25 October 2023

**Re: Design Submission for Former Hickey & co ltd, Park gate street, Dublin, Dublin
(the “Development”)
(the “Design Submission”) / Connection Reference No: CDS23006543**

Appendix A

Drawing Title
Permitted Drainage & Watermain Layout with Proposed Block B2 Amendment

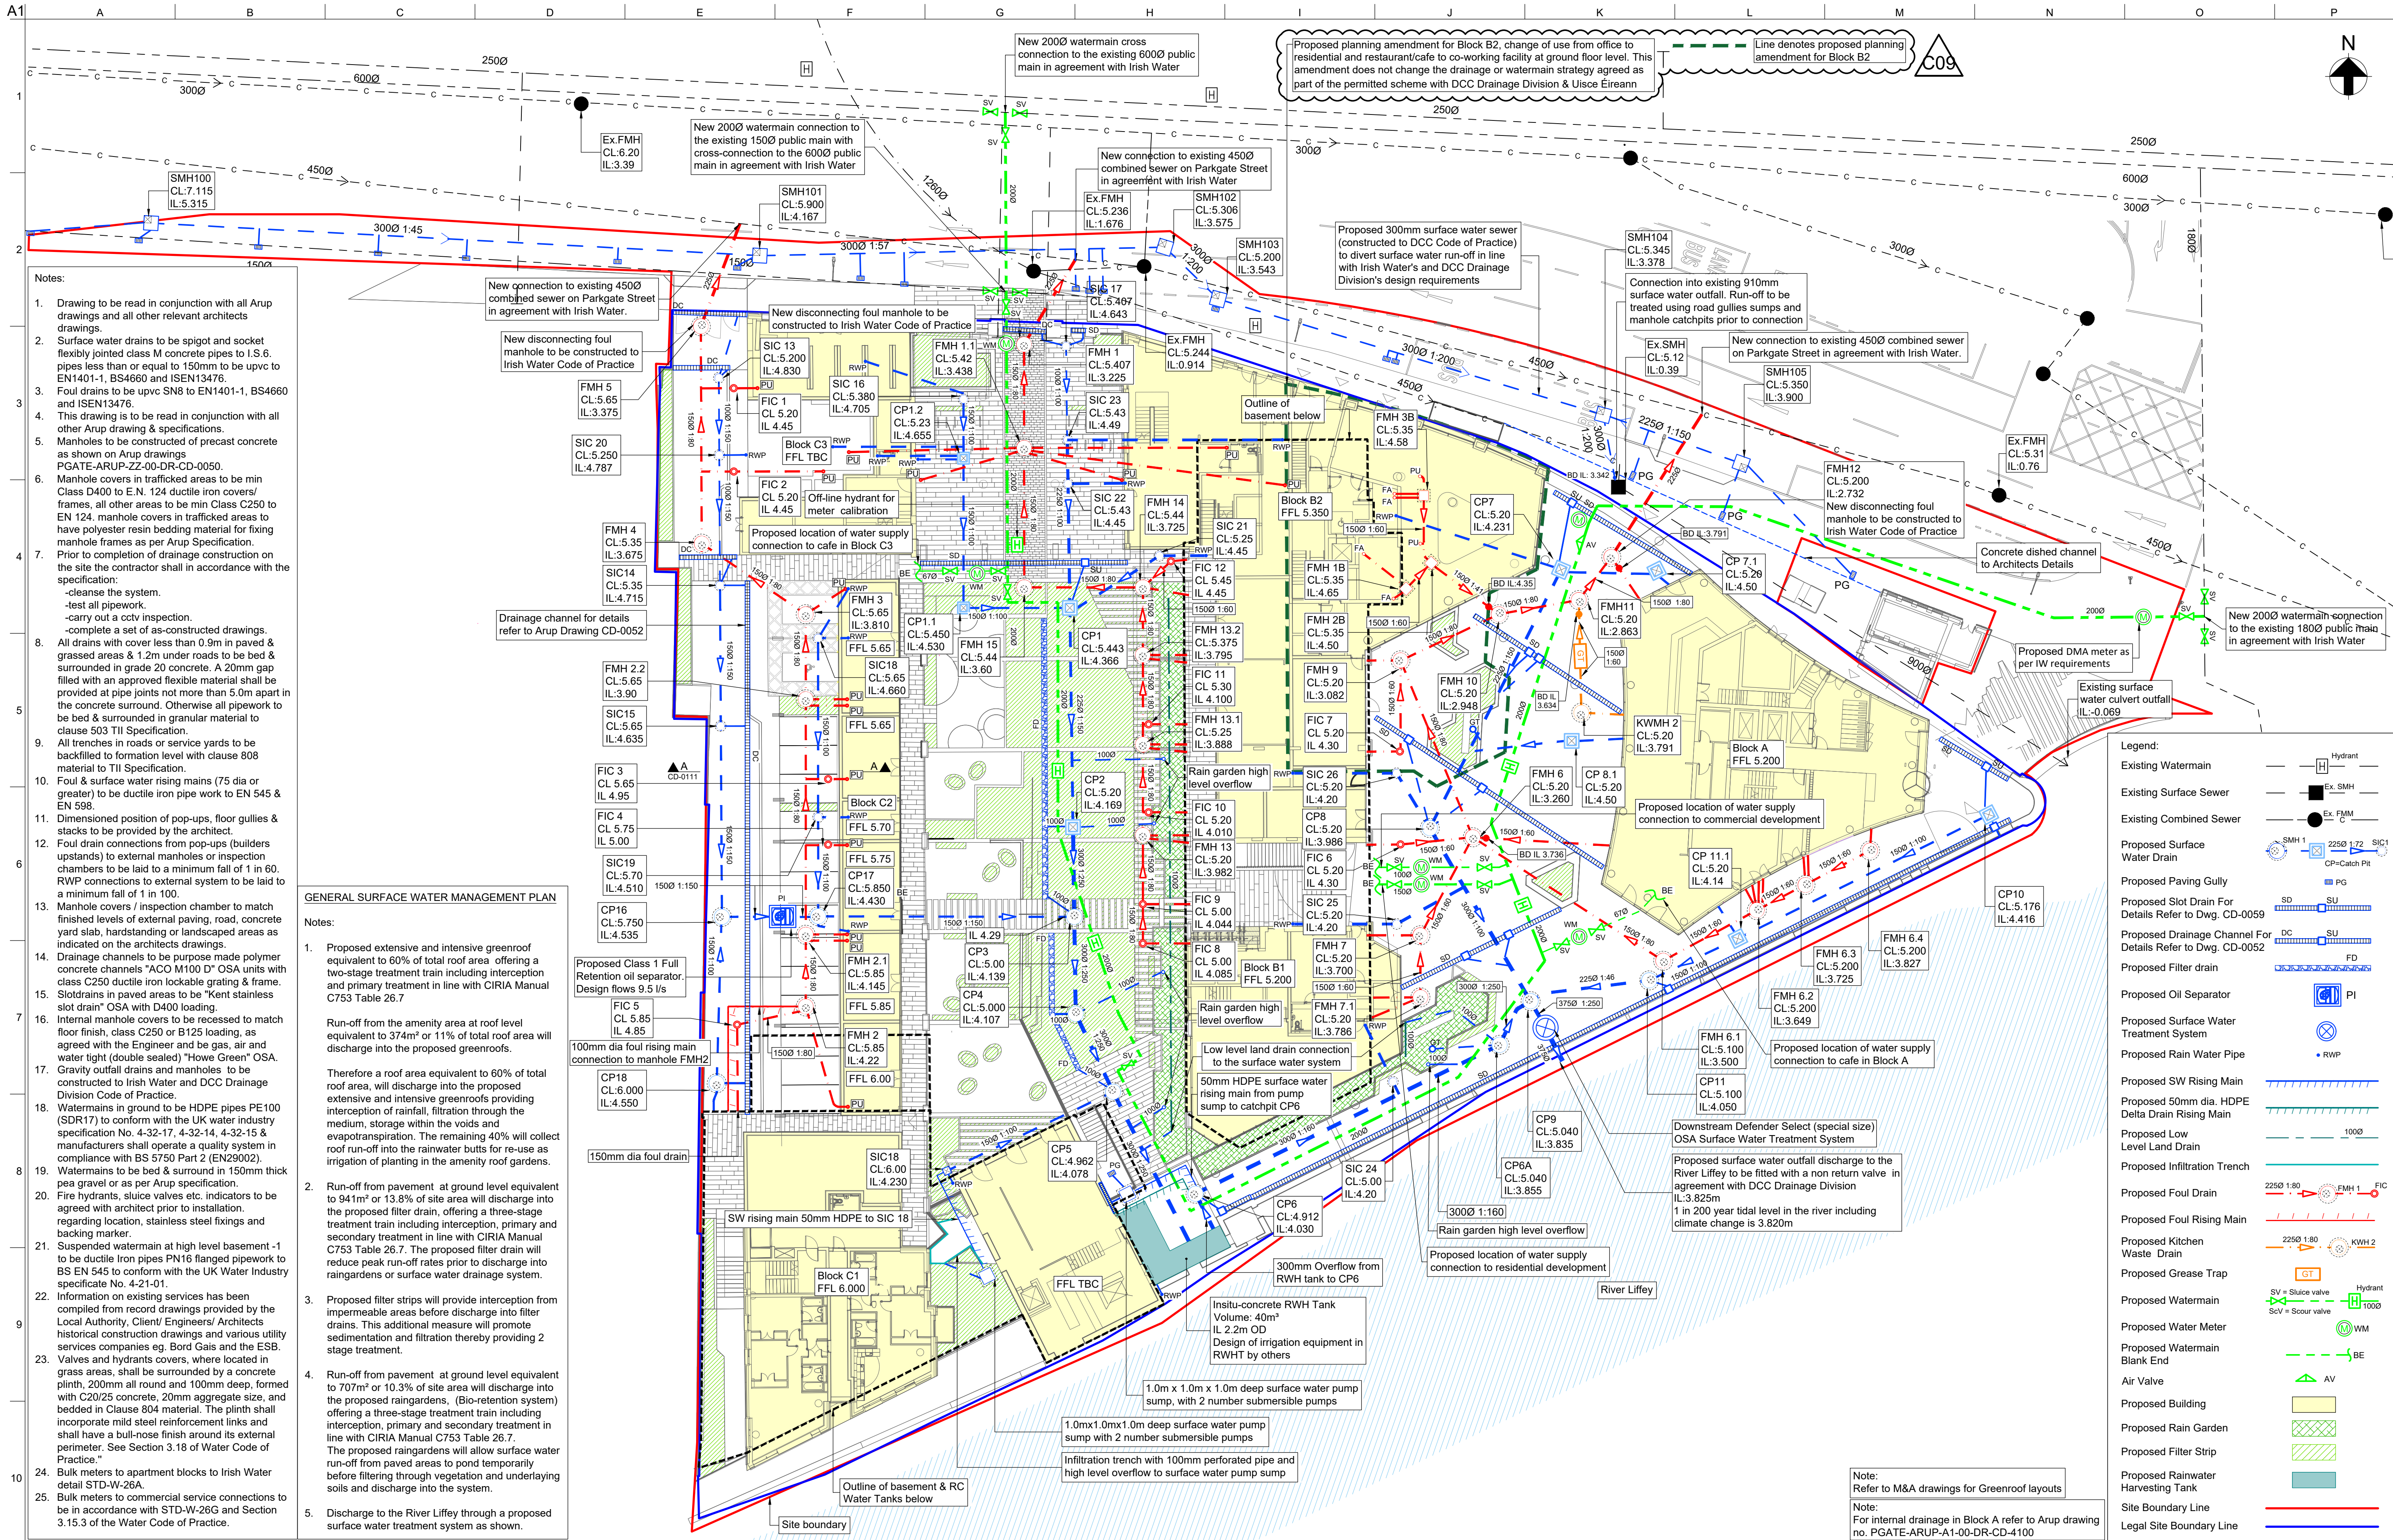
1. *Final connection with the public network and manhole arrangements to be agreed at Connection Application stage.*

While Uisce Éireann notes that the water and wastewater services infrastructure will remain private and not be vested, we have the following comments: It is recommended that the watermain and foul sewer shall have 3 m clearance from proposed or existing structures.
